STAFF REPORT
(One-Step Final Plat)

CASE NUMBER: SUB 2004-84 -- EASTSIDE COMMUNITY CHURCH SECOND ADDITION

VICINITY MAP

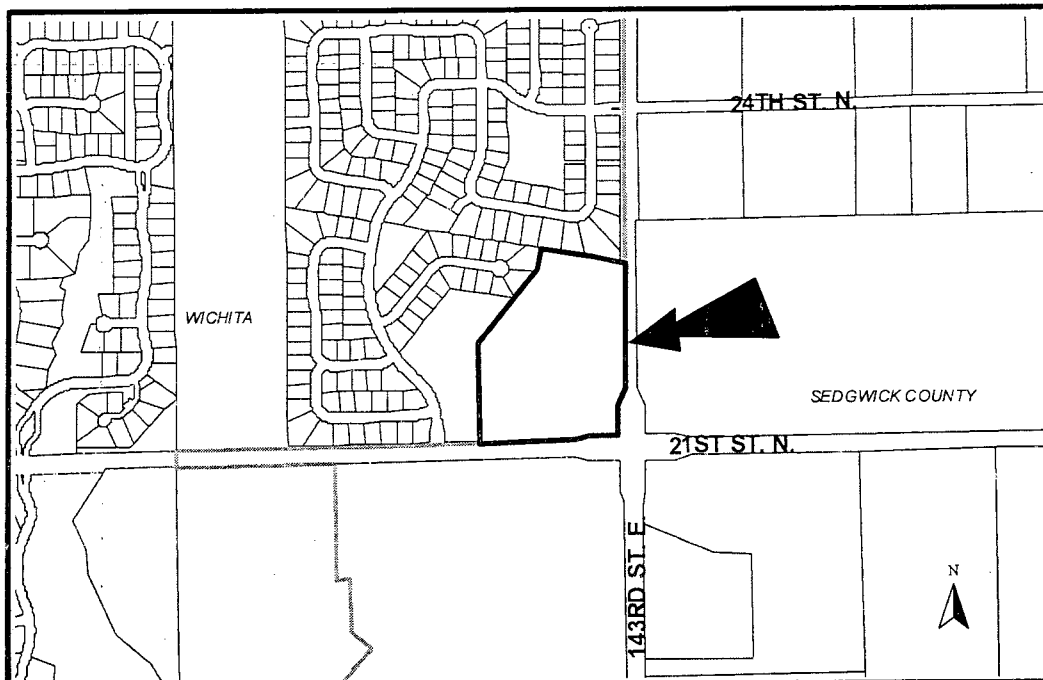
- E. The vicinity map needs revised to correctly reference 143rd Street.
- F. Traffic Engineering needs to comment on the access controls. The plat proposes one opening along both arterial streets. The access controls are approved.
